**Re: 459 US Route 1 - Kittery  
Sketch Plan Application**

**Town of Kittery  
Planning Board Meeting  
December 10, 2020**

**459 U.S. Route 1— Sketch Plan Review / Master Site Development Plan Review**

**1.1**

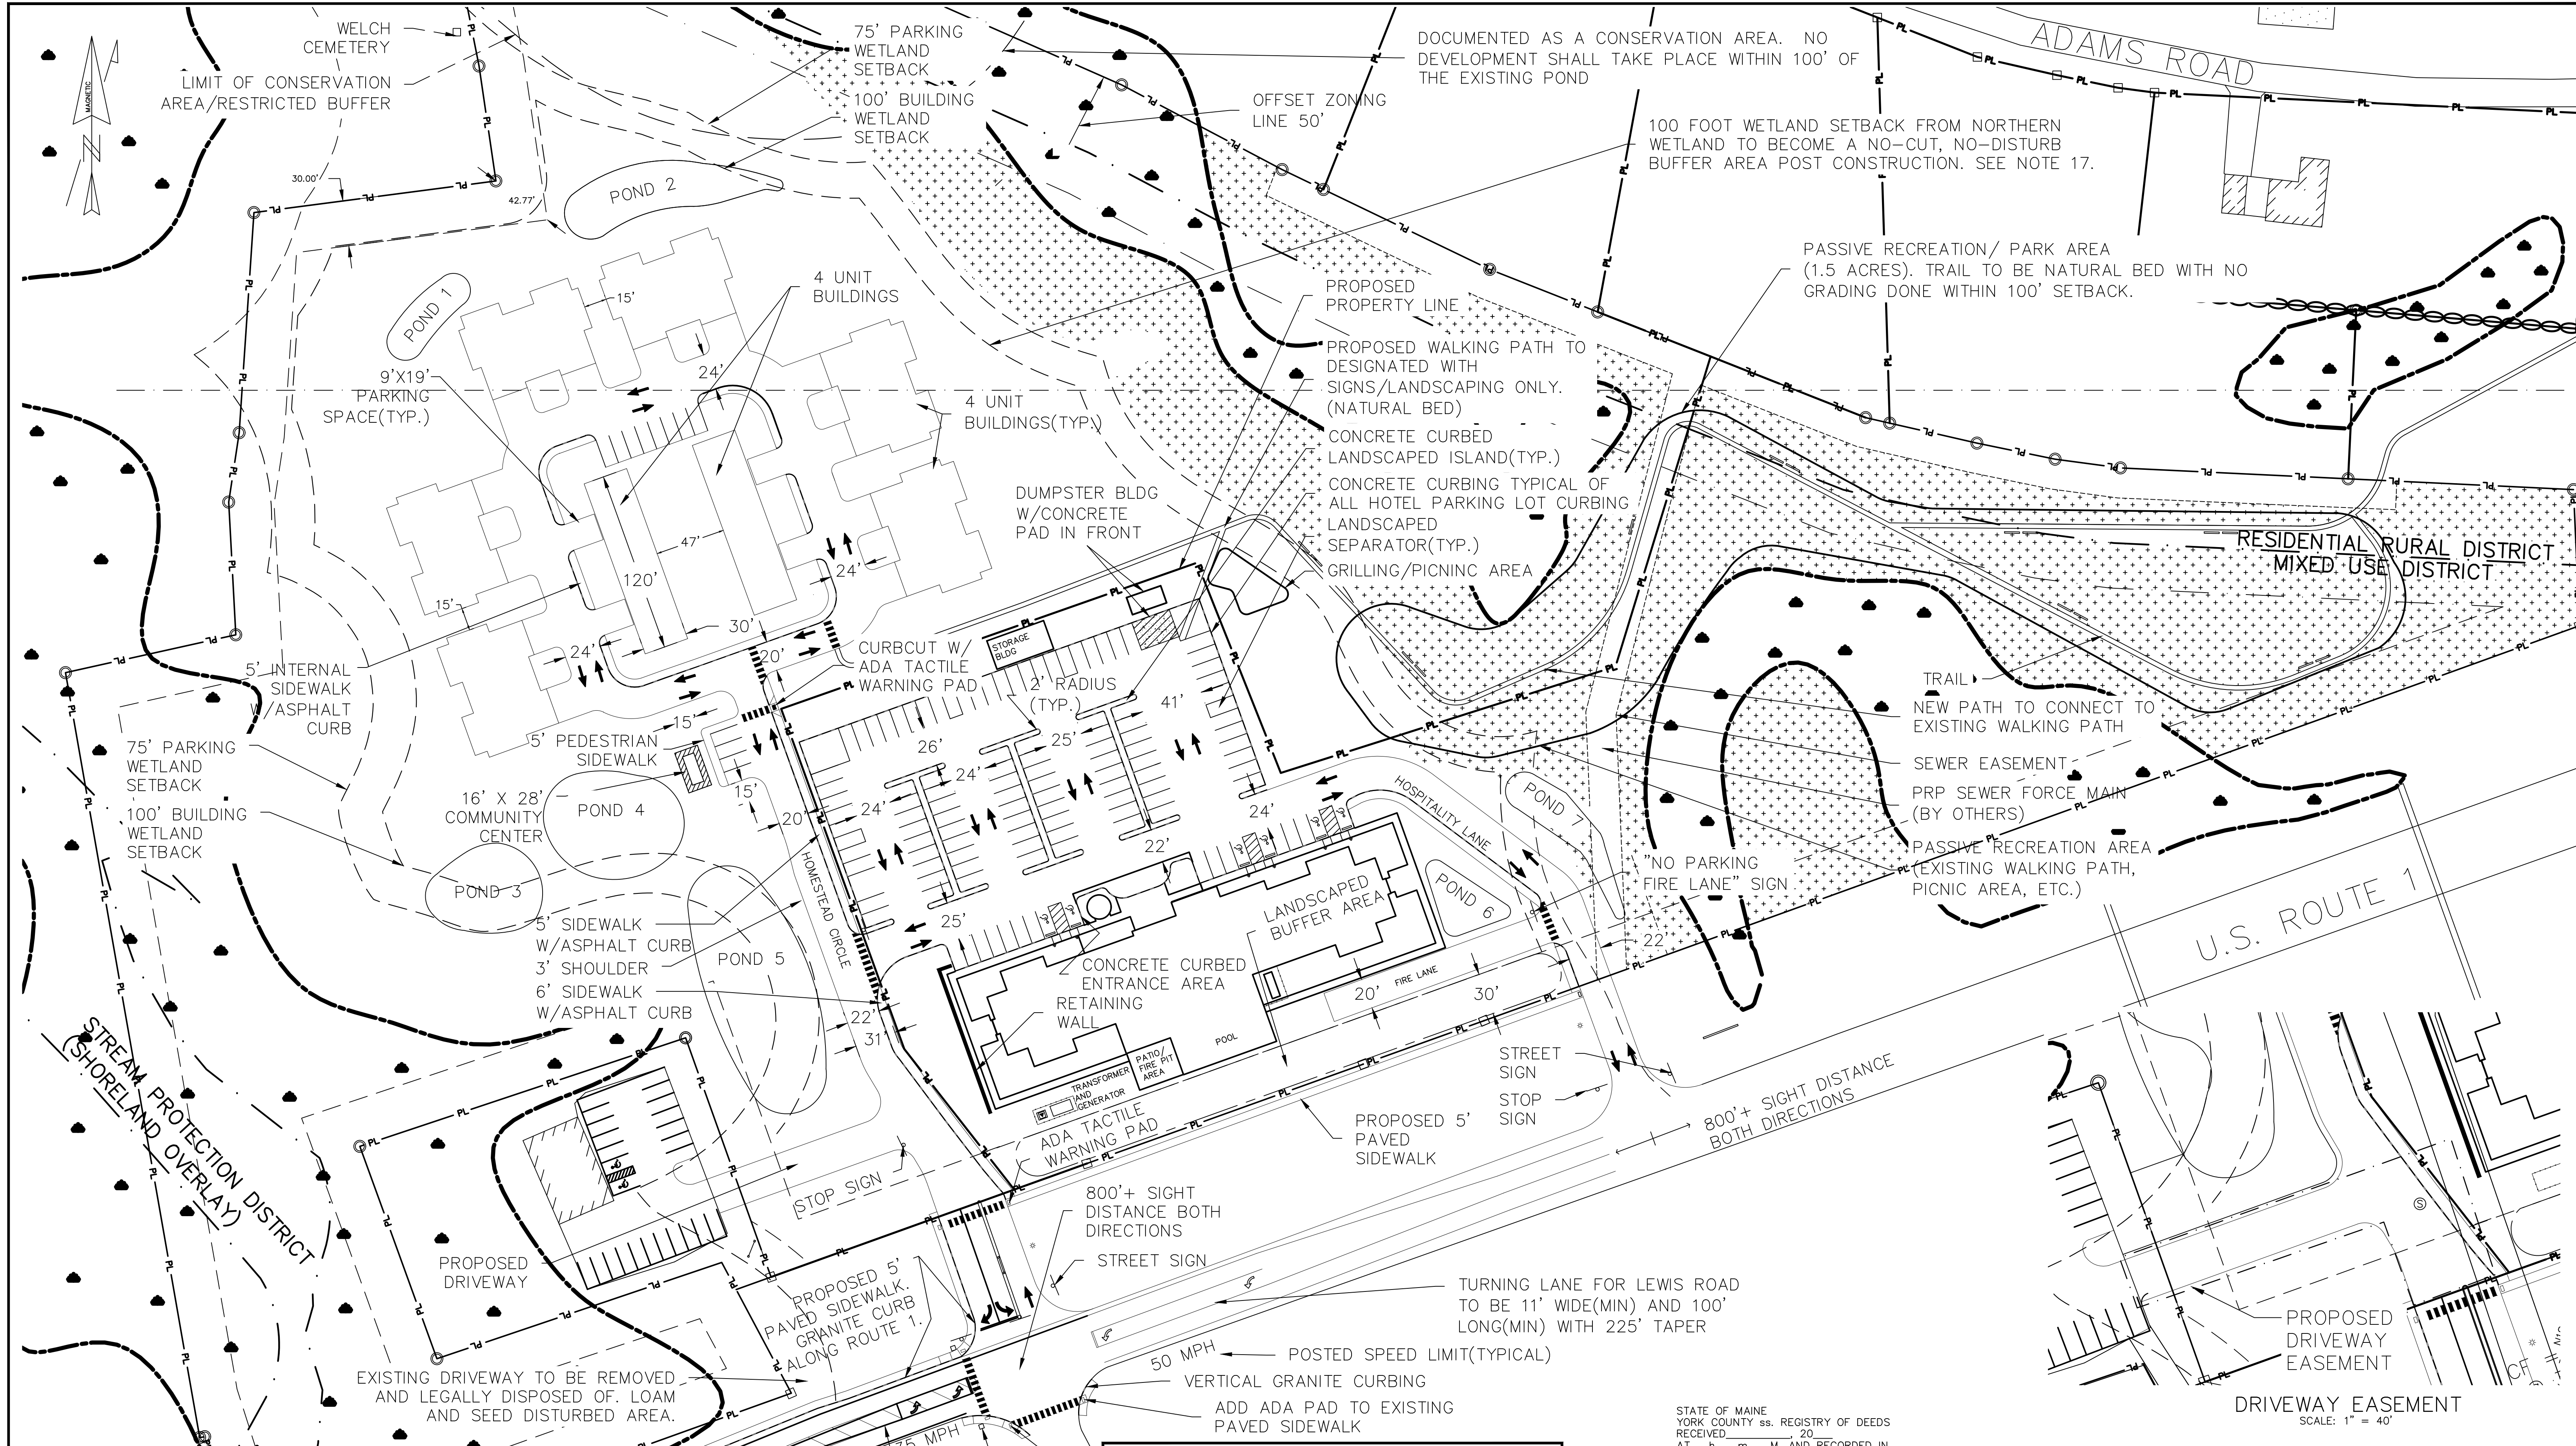
Another reintroduction to the plan is placement of a modestly sized (448-sf), designated community center for residents to congregate and socialize. Originally, the approved plan had a small space in one of the buildings for residents to gather, whereas now a separate building is proposed located to the west of the first stop sign after one turns into the residential development's access way from Route 1. It is unclear what amenities will be offered within the center, but more clarification from the applicant on how the center is imagined to be used should be sought by the Board. The Board should also inquire if there is an alternative location for the community center, as its location is extremely close to a stormwater drainage pond (Number 4). If no reasonable alternative locations are available on the lot, the Board should require verification from the applicant that the pond will not be impaired and its stormwater designed functionality compromised. On the subject of community space and social interaction, the Board should revisit the criteria for elderly housing, pursuant to §16.3.2.13.D(10)(h) *Housing for the Elderly*<sup>1</sup>, and decide whether or not this rendition of the plan is satisfactory. If not, the Board should give direction to applicant on how that can be achieved.
